UNITED STATES PATENT AND TRADEMARK OFFICE

APPLICATION NO.	FILING DATE	FIRST NAMED INVENTOR	ATTORNEY DOCKET NO.	CONFIRMATION NO.
10/501,687	07/16/2004	Renatus Josephus Van Der Vleuten	NL020028	2755
24738 7590 07/19/2007 PHILIPS ELECTRONICS NORTH AMERICA CORPORATION INTELLECTUAL PROPERTY & STANDARDS 370 W. TRIMBLE ROAD MS 91/MG SAN JOSE, CA 95131			EXAMINER MOON, SEOKYUN	
			ART UNIT 2629	PAPER NUMBER
			MAIL DATE 07/19/2007	DELIVERY MODE PAPER

Office Action Summary	Application No. 10/501,687	Applicant(s) VAN DER VLEUTEN ET AL.	
	Examiner Seokyun Moon	Art Unit 2629

DETAILED ACTION

Drawing 1

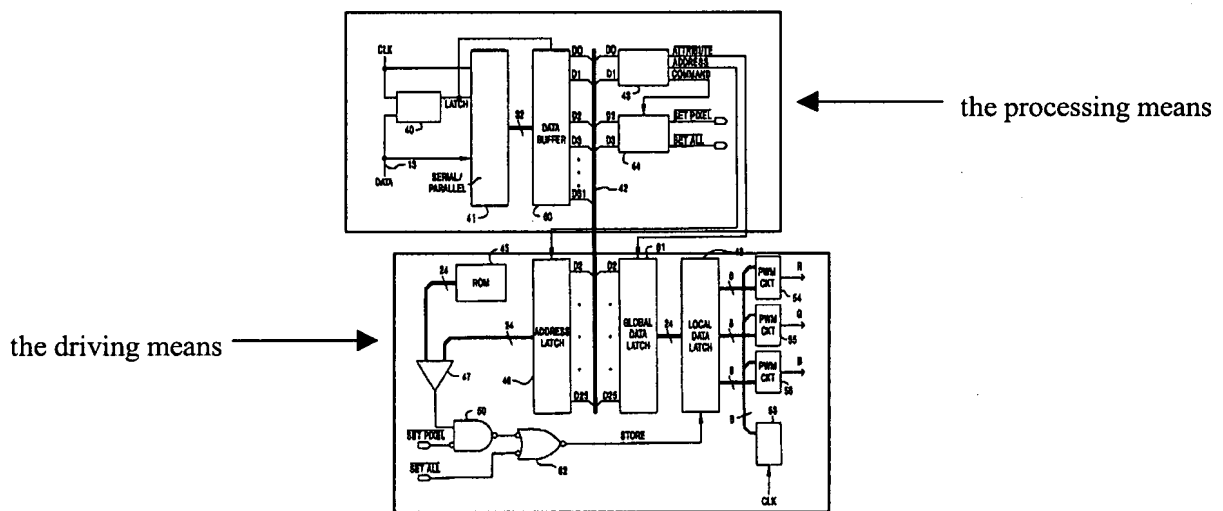
Ryan does expressly teach the processing means [drawing 1 provided below, which is equivalent to fig. 9 of Ryan] for receiving encoded data provided in a compressed format [abstract lines 8-10, col. 2 lines 51-53, and col. 3 lines 7-8] according to an international standard (“*run length encoded global command*”, i.e. RLE) [col. 3 lines 8-11] and for providing data to the drive means [drawing 1] [col. 8 lines 12-44].

Furthermore, Ryan inherently teaches the data processing means decoding the encoded data to provide the decoded data to the drive means since it is required for the data processing means of Ryan to decode the data encoded in a compressed format in order to control the pulse width modulation circuits properly according to the encoded data, thus to allow the device of Ryan to display images with right colors.
